CELL 4 DESIGN

WHITE MESA PROJECT
BLANDING, UTAH

Re: Cell 4 Design
White Mesa Project
Docket No. 40-8681 04008681210R

Cell 4
White Mesa Project

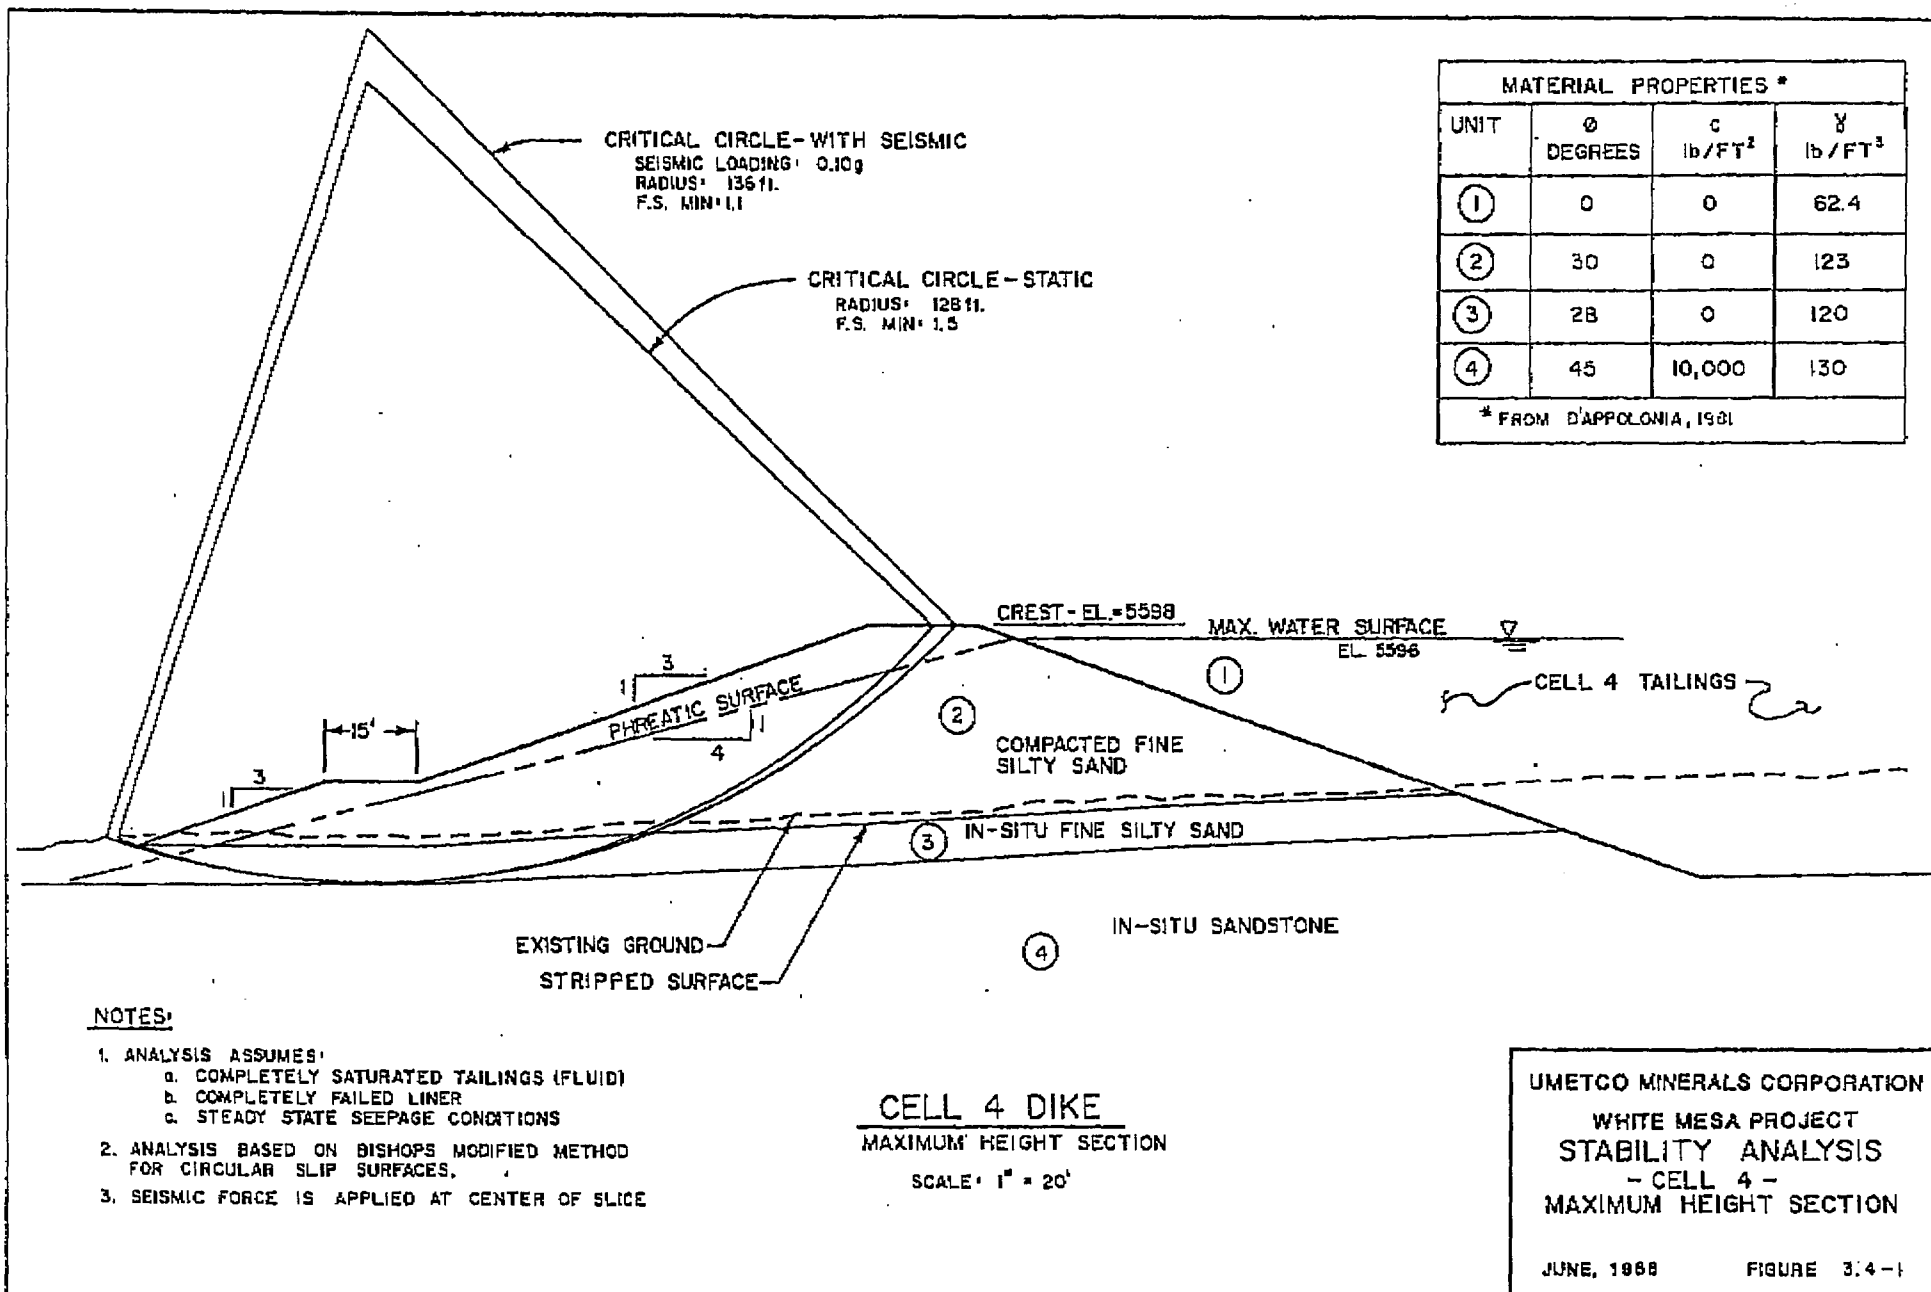
2. The settlement analysis referred to in the plan must be submitted. The results should substantiate that the magnitude of the total and differential settlement will not result in harmful cracking or dam instability.

Please also note Figure 3.4-1 of the Cell 4 design package. The stability analysis assumes that the synthetic liner has completely failed and that a phreatic surface (steady state seepage conditions) has developed within the embankment, adding to the conservatism of the analysis.

For the sake of conservatism, the stability analysis that was performed ignored the effects of side friction on the critical slide mass. Therefore, with respect to our evaluation, a change in the dike geometry laterally bounding the analyzed section would have no effect. This means that, using the same methods of analyses the only change in safety factor would be due to differing embankment geometry such as height and slopes. The embankment slopes around the curve are identical to the rest of the dike. The height at the curve is less than at the section analyzed which will result in an increase in factor of safety at the curve.

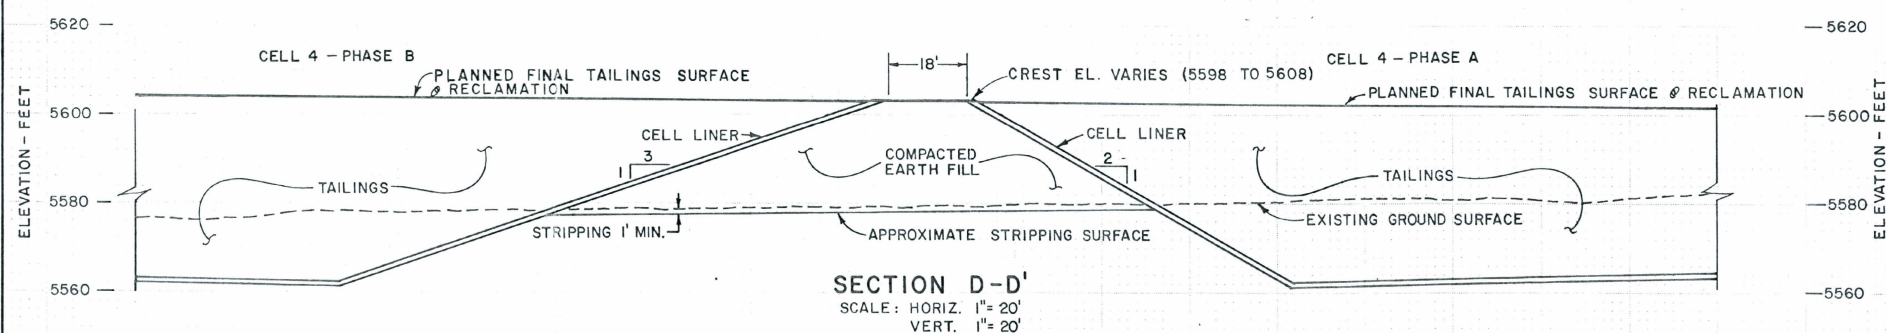
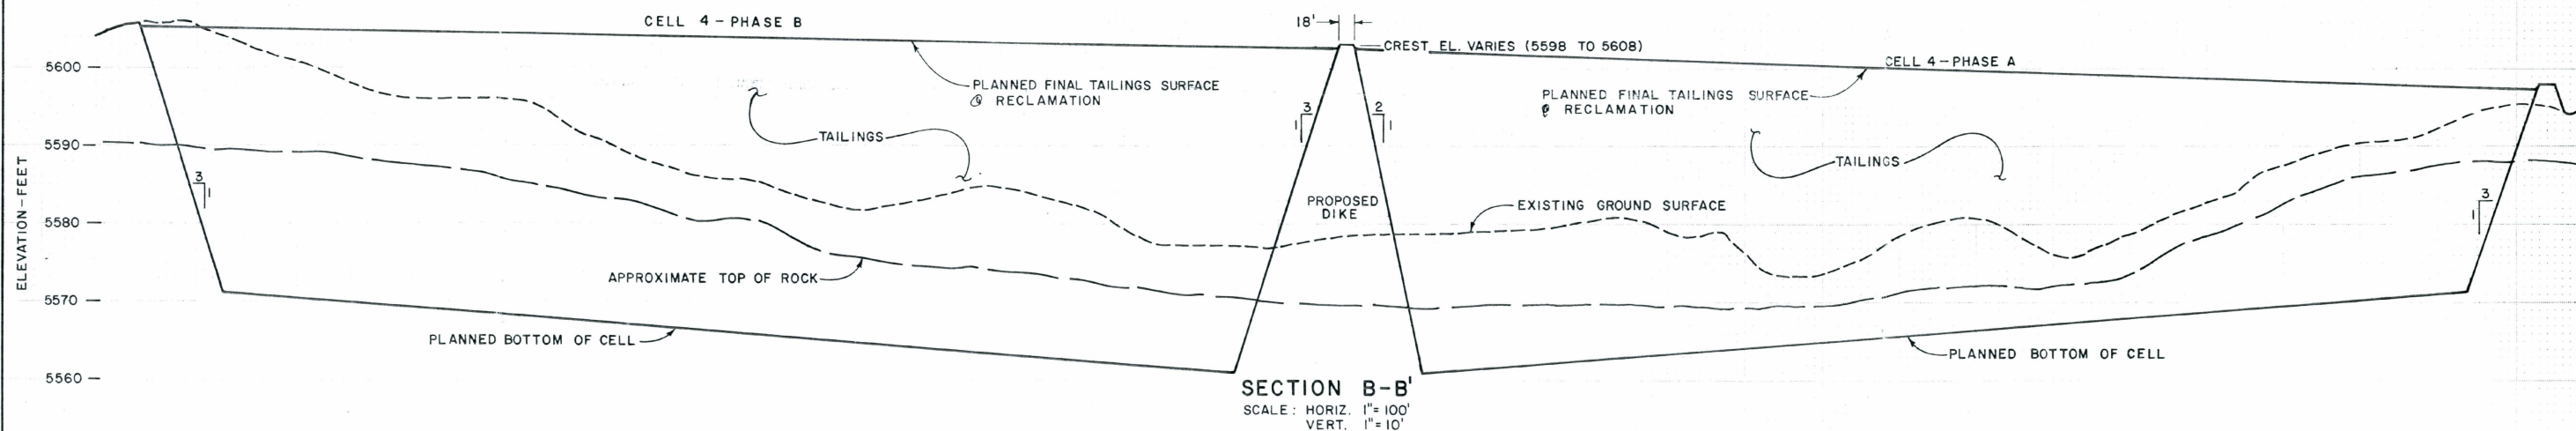
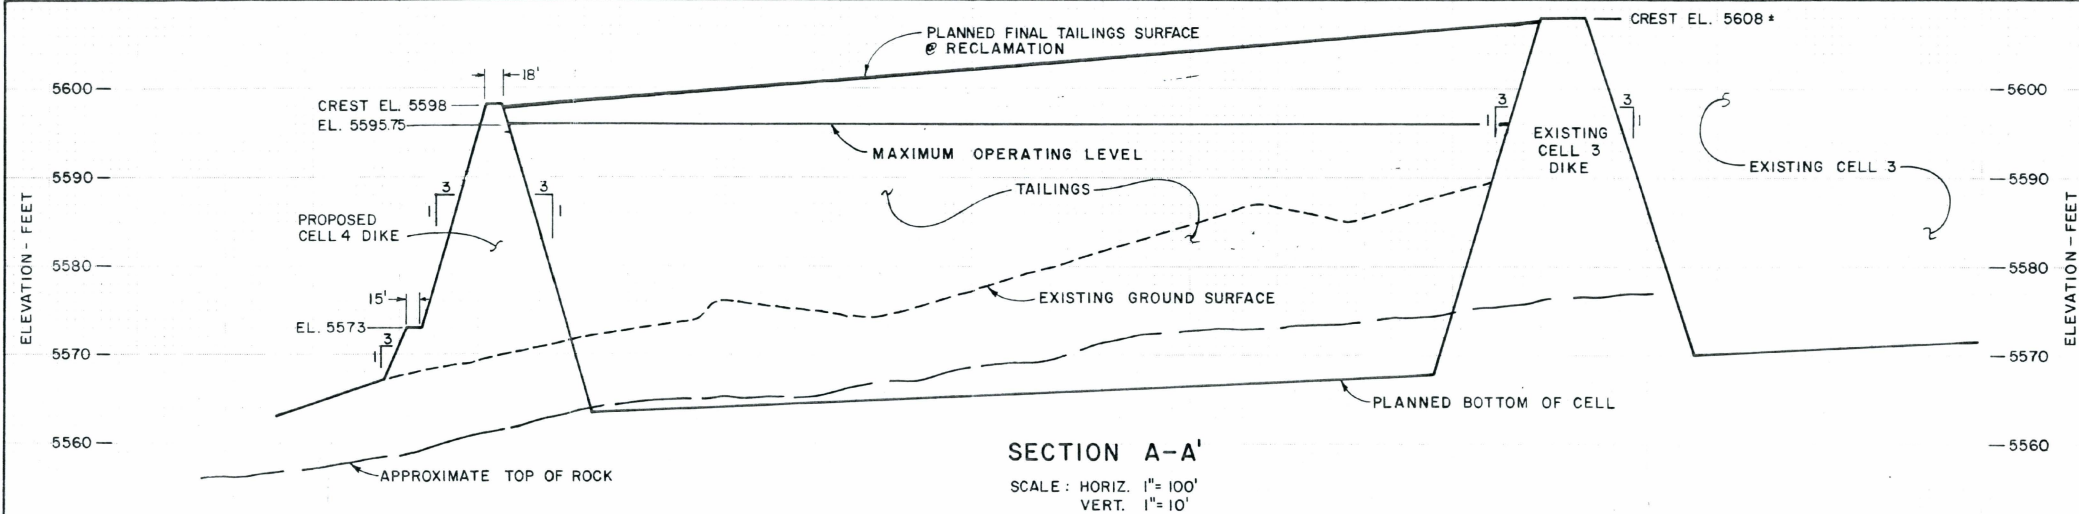
1. The surface water design must be included in the design package. The design must establish sufficient freeboard in the cells to allow for settlement and wind wave runup, along with providing available storage capacity to store the entire inflow from a 6-hour Probable Maximum Precipitation (PMP) event. For design purposes, you should assume that the reservoir level at the beginning of the PMP event is at the maximum level expected during the design life of the cells. The diversion ditch design must also be included in the design package.

Umetco will operate the cell to contain the PMP event of 10 inches with an additional 1.5 feet of freeboard to provide for wave runup due to wind. (See attached Drawing C4-2.)
